ORDINANCE NO. 5321

AN ORDINANCE AMENDING ORDINANCE NO. 4441, WHICH ADOPTED THE CITY OF ALBANY ZONING MAP; APPROVING A SUBDIVISION TENTATIVE PLAT; AND DECLARING AN EMERGENCY; FOR PROPERTY LOCATED SOUTH OF SANTIAM HIGHWAY AND WEST OF INTERSTATE 5.

FINDINGS DOCUMENT

Zoning Map Amendment File ZC-04-97

EXHIBIT C

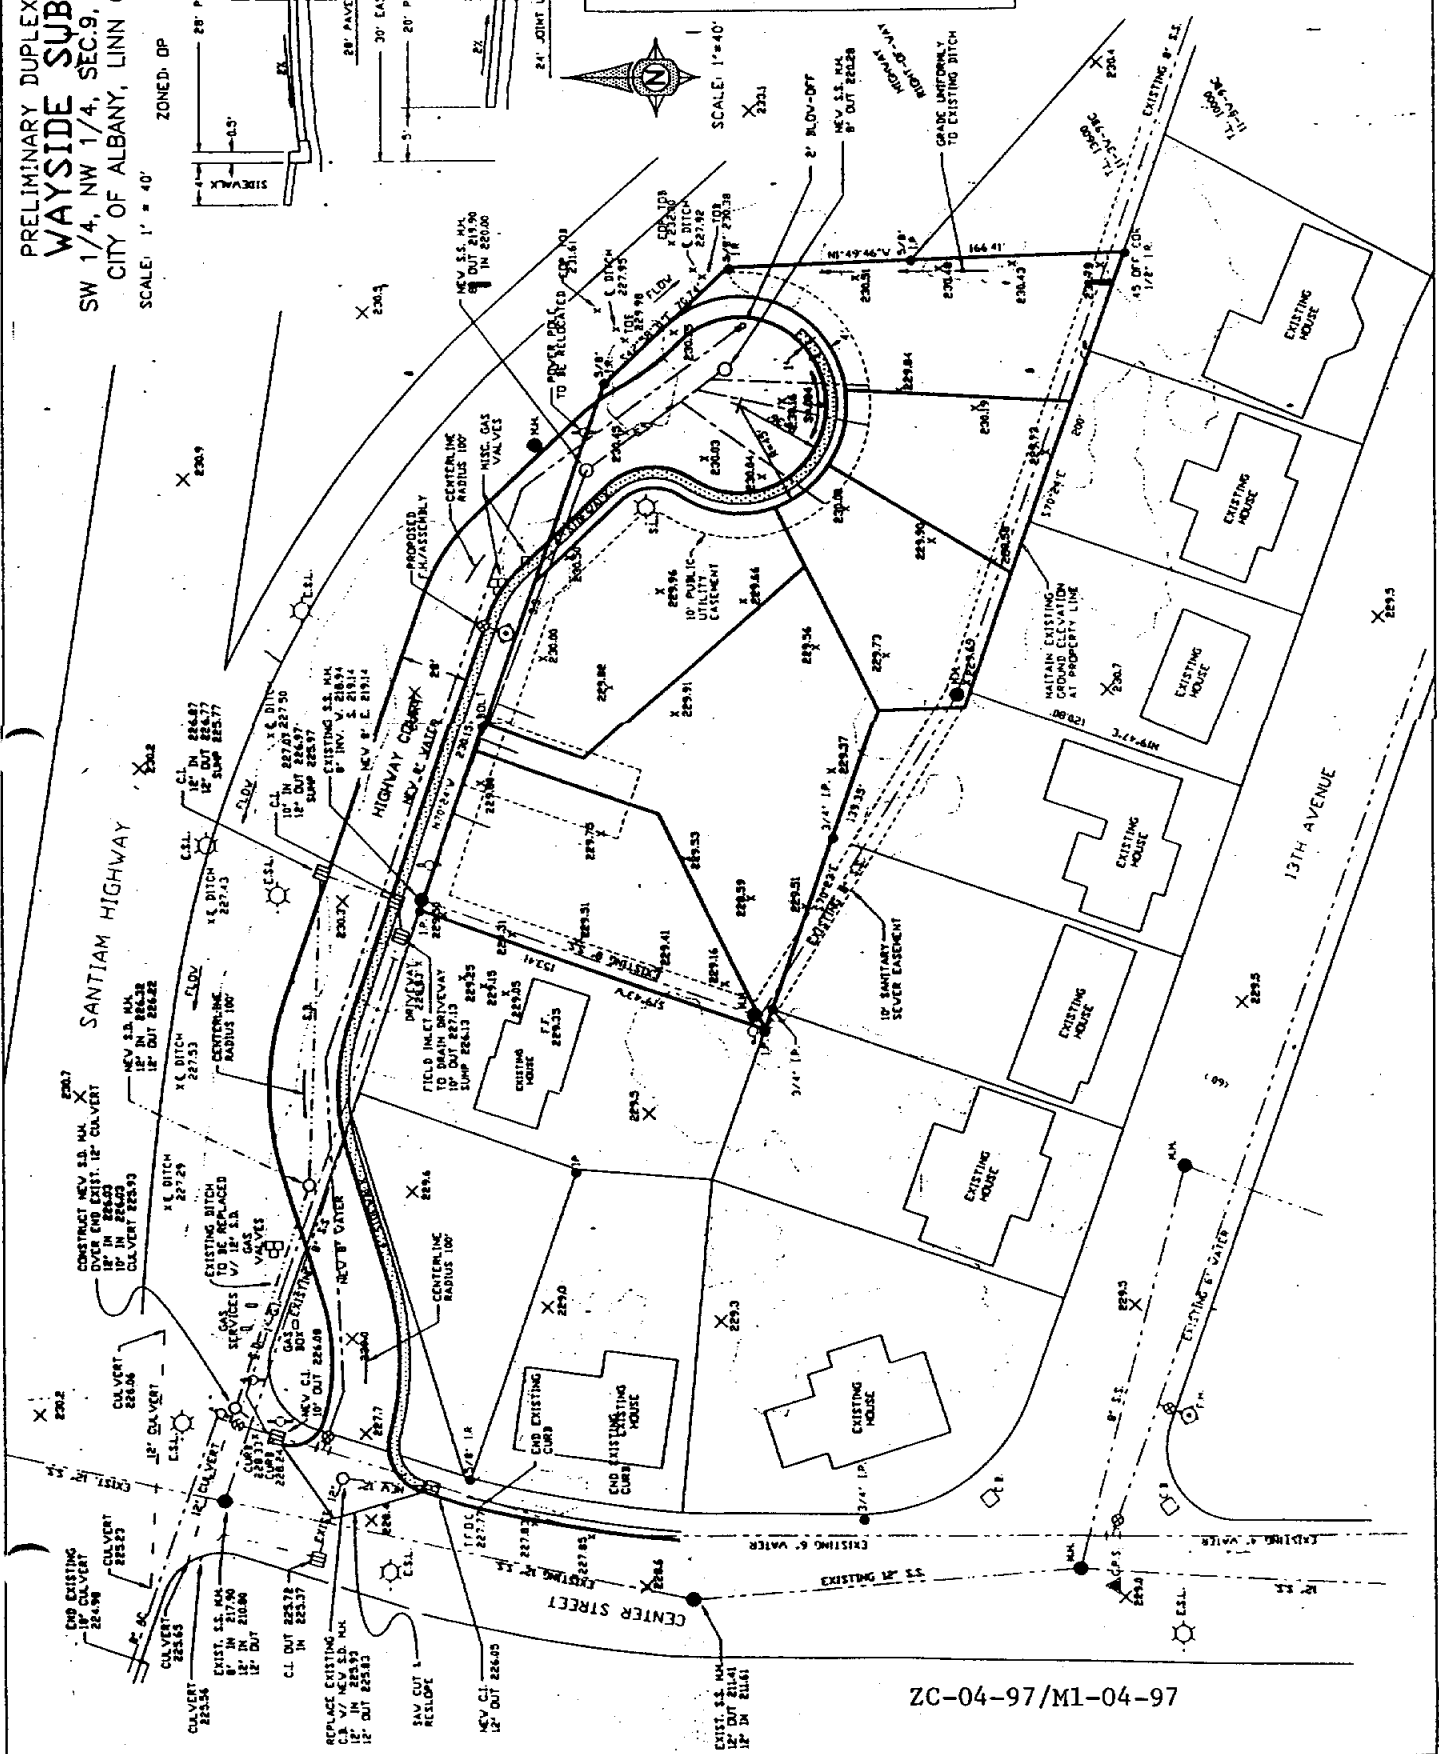
3.6 Flag Lots: ADC 11.090(7) says flag lots are discouraged and allowed only when absolutely necessary to provide access to buildable sites and only where the dedication and improvement of a public street cannot be provided. The tentative plat shows one flag lot (Lot 2). This flag lot is necessary to provide access to a buildable site along the south boundary of the subject property. Dedication and improvement of a public street cannot be provided because the property is bounded on the north and east by Interstate 5 and an on-ramp, and on the south and west by developed single-family lots.

ADC 11.090(7) also requires the minimum width for a flag lot to be 22 feet, except where access is shared by an access and maintenance agreement, in which case each lot shall have a minimum width of 12 feet and a combined width of 24 feet. The plat shows the flag lot to be 12 feet wide. The plat shows

a "joint use easement" on the 12-foot width of the flag lot and 12 feet of the adjoining Lot 1. The combined width of the easement is 24 feet, which meets the Development Code requirement.

- 3.7 ADC 12.210 requires that center line radii on local streets shall not be less than 200 feet. The tentative plat shows two 100-foot radius curves. However, the Development Code allows exceptions where it is impractical to build 200-foot radius curves. It is impractical to build 200-foot radius curves here because it would create a very wide strip of right-of-way that would not be used and would not be maintained.

- 4.4 The tentative plat shows an 8-inch public main to be extended from an existing manhole at the northwest corner of the subject property, along the north boundary of the property, into the proposed cul-de-sac bulb.

- 4.5 The tentative plat shows each duplex lot to be served by one sewer lateral. This is acceptable, but no further division of the proposed lots is allowed unless each new lot also has its own private sewer connection to the public sewer, constructed to City standards.

- 4.6 The City of Albany does not allow private sanitary sewer lines to cross property lines. The private lateral to the flag lot (Lot 2) must lie within the flag portion of the lot.

The tentative plat shows the existing sewer located approximately 5 feet off the west and south boundaries of the property. So, an additional 5 feet of easement will be needed. However, the exact location of the existing sewers must be determined. The property owners will have to determine the location of the existing sewer, and provide the required easement that falls on their property. (For example, if the sewer is actually located on the property boundary, only 10 feet is needed on the subject property, so the existing easement would be adequate. The other 10 feet would be needed on the adjacent property.)

- 4.12 The tentative plat shows a proposed 8-inch public water main to be built from the existing 6-inch line in Center Street, east into the proposed cul-de-sac bulb. A fire hydrant is proposed on the new water main, approximately 120 feet east of the west property line of the subject property. The location of the fire hydrant must be approved by the City of Albany Fire Department and the Public Works Engineering Division.

- 4.13 The tentative plat does not show individual water services for the proposed lots. It is acceptable to serve each lot with a single water service or separate services can be provided to each of the proposed duplex units on each lot. If a single water service is provided to each lot, the lots cannot be divided further, unless each new lot is provided a separate water service line. Each lot must have a separate service line which is located within the boundaries of the property it serves. Private service lines may not cross property lines.

- 4.14 It appears that a new catch basin to be constructed at the corner of Center Street and the proposed new street (Highway Court) will be located on the existing 1-inch water service that serves 3130 Santiam Highway SE. It will be necessary to replace this service and connect it to the new 8-inch water line.
